WINDERMERE PRELIMINARY PLAN

$E^{1/2}$ OF SECTION 29, T13S, R65W OF THE 6TH P.M. EL PASO COUNTY, COLORADO

WINDERMERE METRO DIST. COUNTY FILE NO.: SP-19-003 | SHEET: 1 OF 10

SP19003-V2-PrelimPlan redlines.pdf Markup Summary 8-20-2020

COUNTY FILE NO.: SP-19-003 SHEET: 2 OF 10

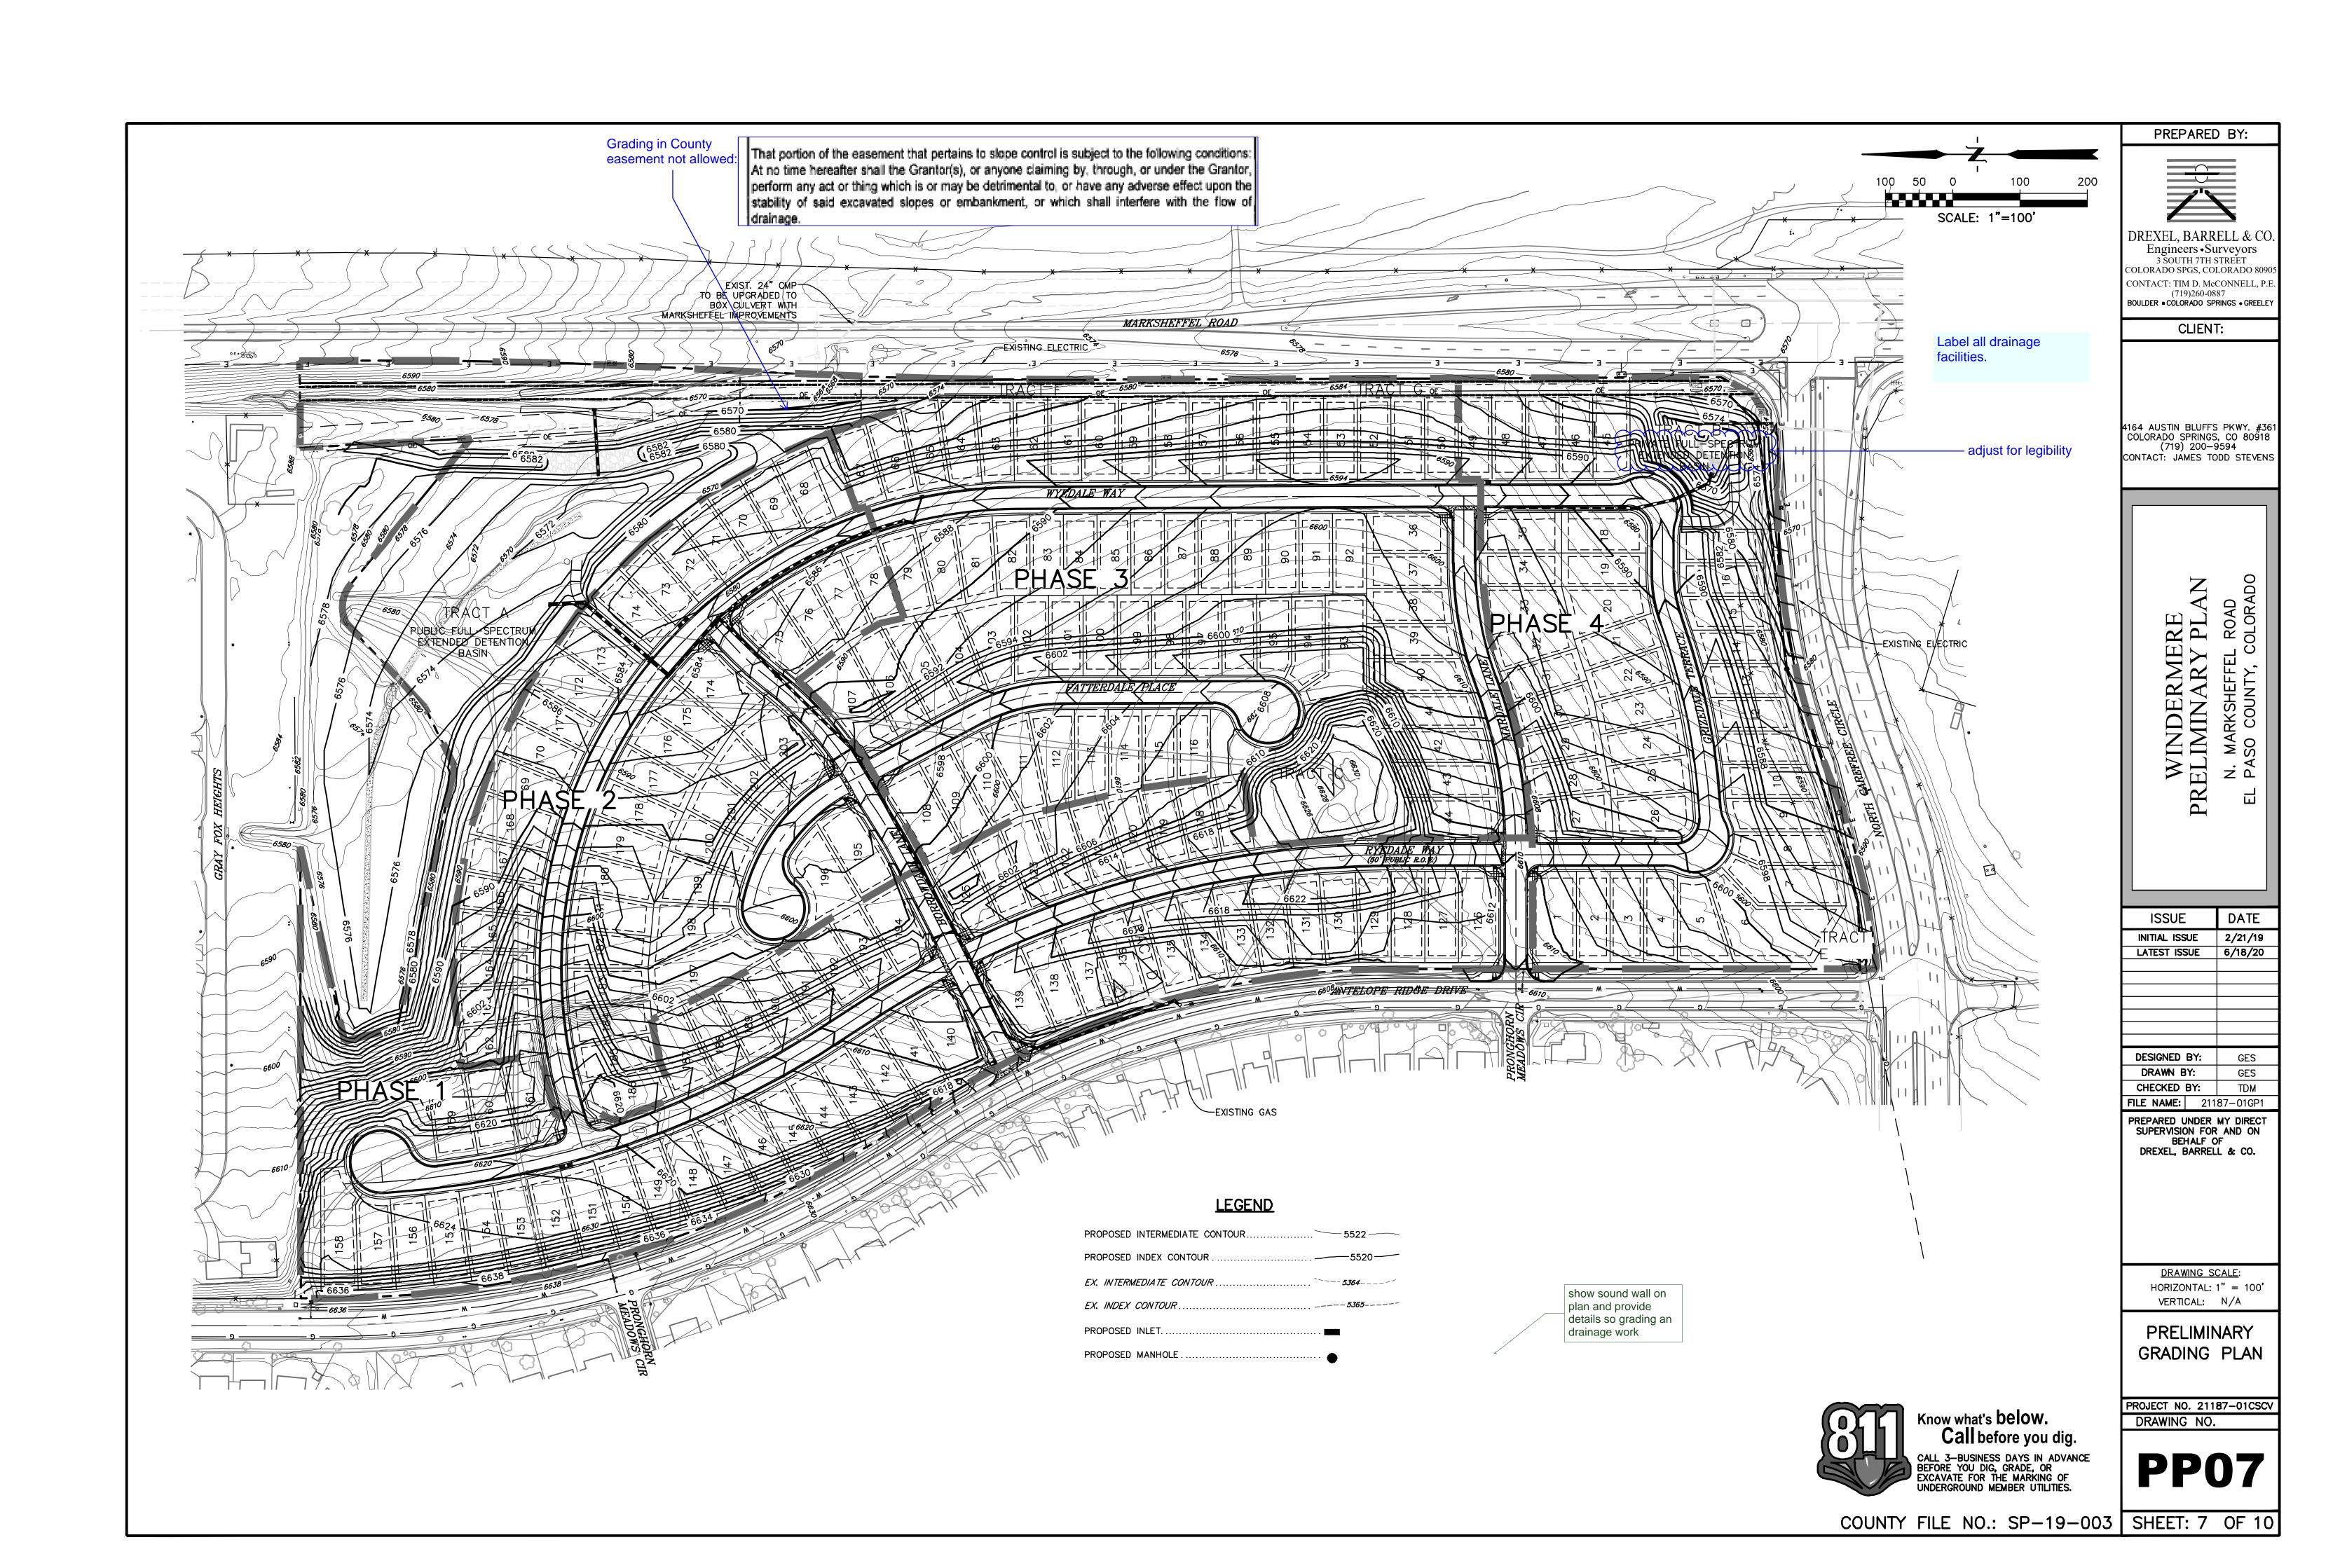
Status: Color: Layer: Space: Show the adjacent property/ROW lines

Status: Color: Layer: Space: wall can't be in the ROW

Status: Color: Layer: Space: Dimension the ROW dedication and total width at applicable locations. This doesn't match MTCP.

Subject: Callout title every page Page Label: [2] 2 21187-01SP1 - SP1 Author: dsdparsons Date: 8/20/2020 5:03:46 PM Status: Color: Layer: Space: Subject: Callout phase plan Page Label: [2] 2 21187-01SP1 - SP1 Author: dsdparsons Date: 8/20/2020 5:04:05 PM Status: Color: Layer: Space: Subject: Callout preliminary plan Page Label: [3] 3 21187-01SP1 - SP2 Author: dsdparsons Date: 8/20/2020 5:04:19 PM Status: Color: Layer: Space: Subject: Callout phase plan Page Label: [1] 1 21187-01CV1 - DP01 Author: dsdparsons Date: 8/20/2020 5:04:42 PM Status: Color: Layer: Space: Subject: Callout preliinary plan Page Label: [1] 1 21187-01CV1 - DP01 Author: dsdparsons Date: 8/20/2020 5:04:53 PM

ROW Preservation?

ROW dedication?

COUNTY FILE NO.: SP-19-003 SHEET:10 OF 10

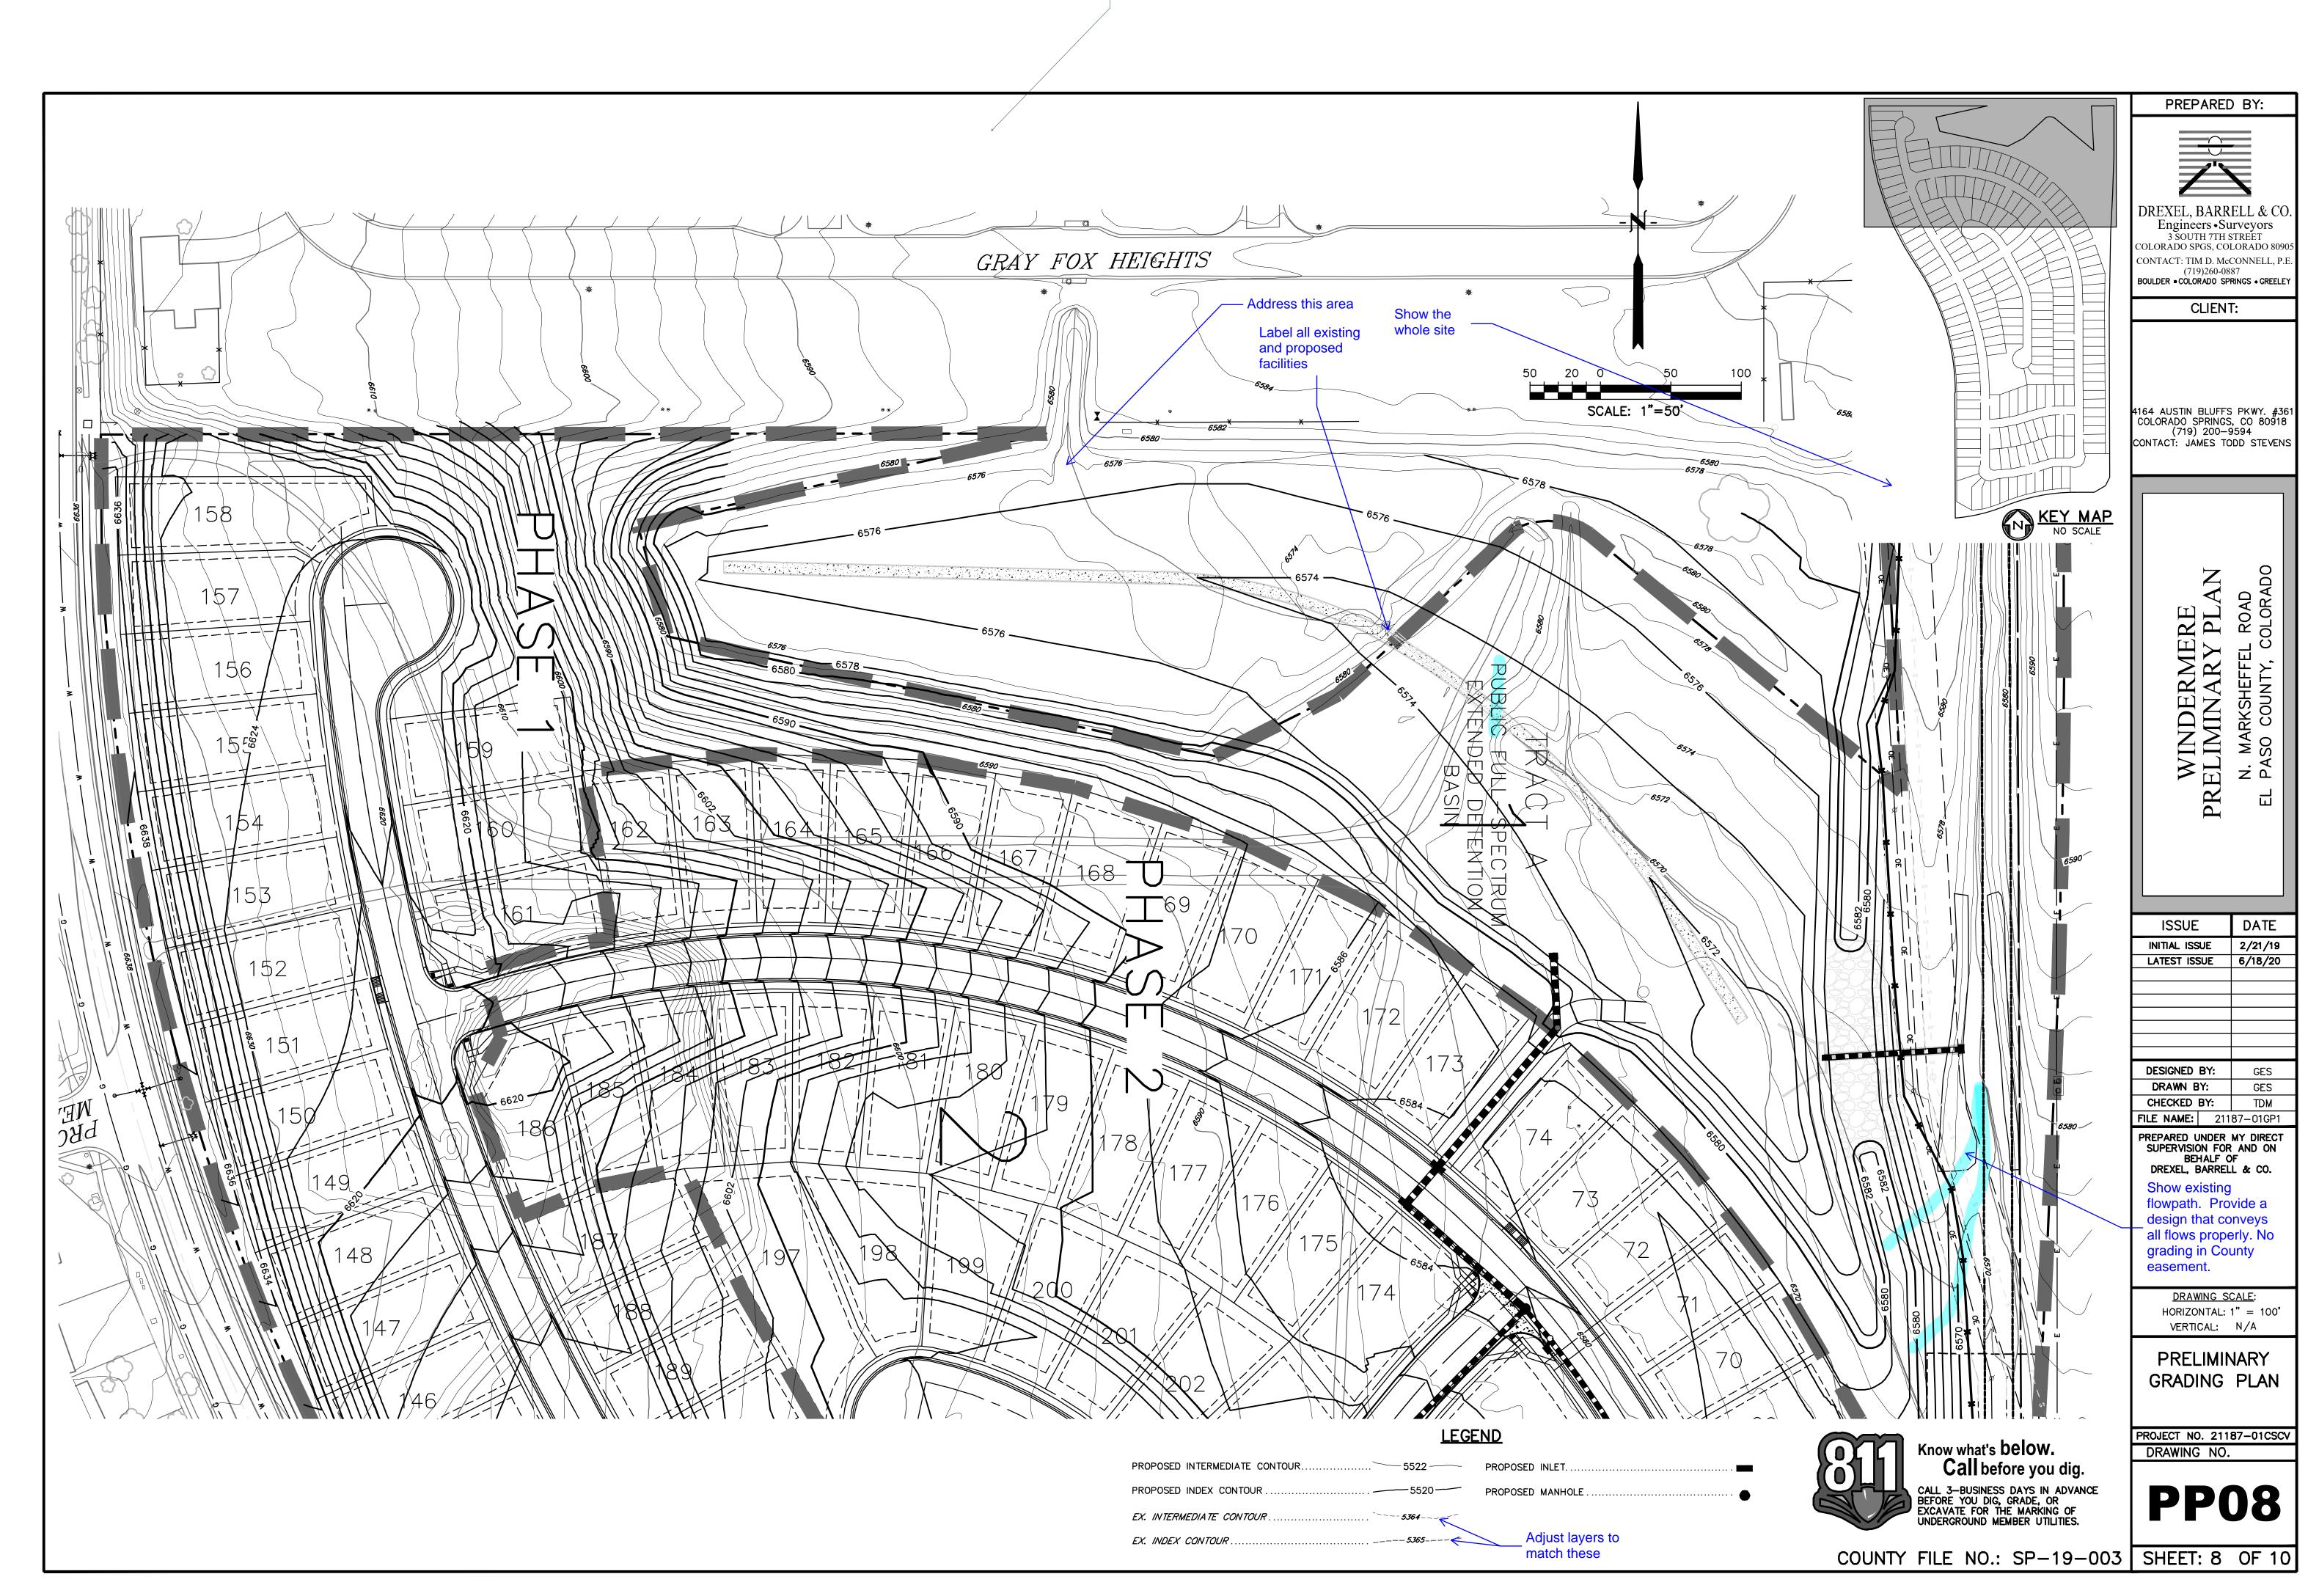
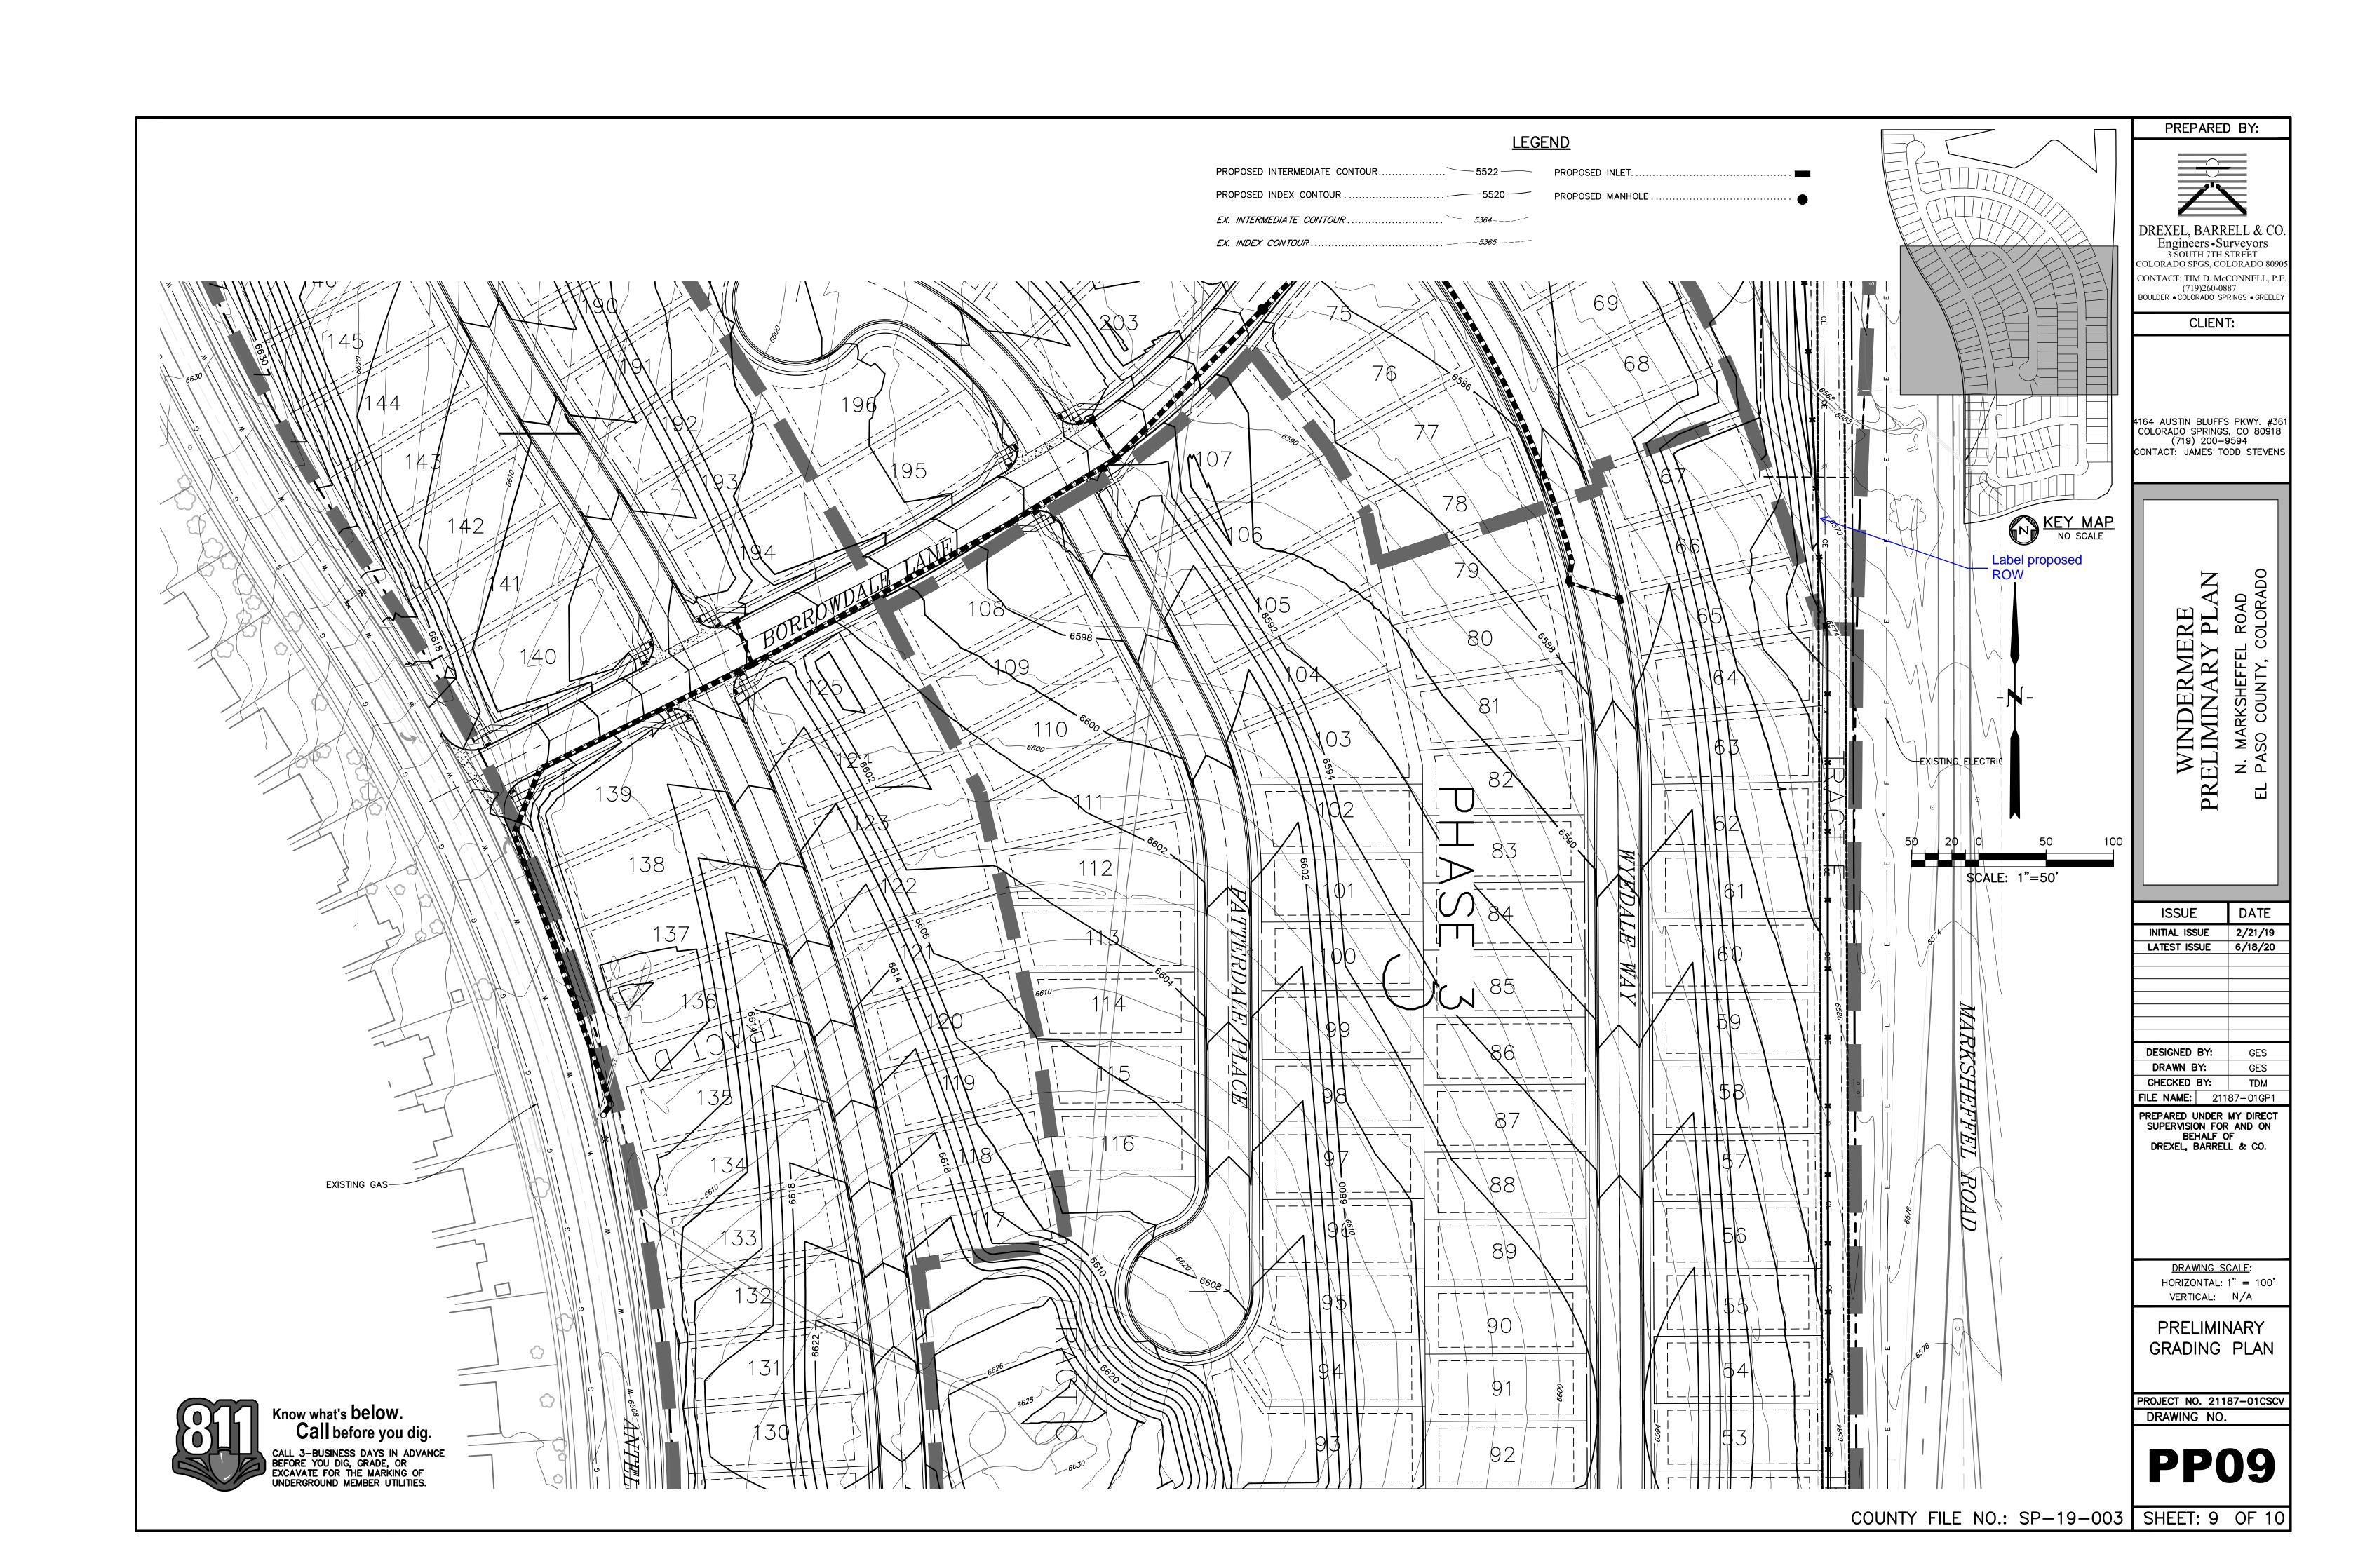
Status: Color: Layer: Space: Show the whole site

Status: Color: Layer: Space: Label all existing and proposed facilities

Status: Color: Layer: Space: Show existing flowpath. Provide a design that conveys all flows properly. No grading in County

Status: Color: Layer: Space: Label proposed ROW

Status: Color: ■ Layer: Space: show sound wall on plan and provide details so
